Technical Service Bulletin

Cobra Motorcycle Mfg.

TSB1107: CX65 Top End

May 21, 2007

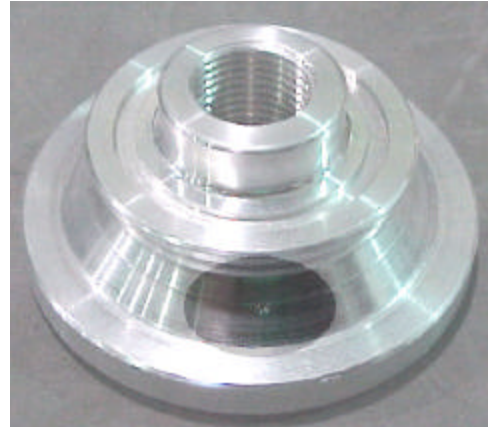
The cylinder on the Cobra 2007 CX65 was supplied to Cobra, from the manufacturer, with incorrect specifications. Cobra can best take care of its many customers through factory controlled changes to the cylinder and a correspondingly different cylinder head.

An updated cylinder can be recognized by having a "U" stamped in near the exhaust as shown below. The cylinder head can be recognized by having a 'dimple' on the water-jacket surface shown.

All units produced of Revision 1.5 and higher will have this upgraded hardware direct from Cobra. Customers with units produced prior to Rev 1.5 may call into Cobra and arrange an upgrade of cylinder and head. This will require the customer to receive a proper Return Authorization number (RA#) prior to sending in their cylinder and head.
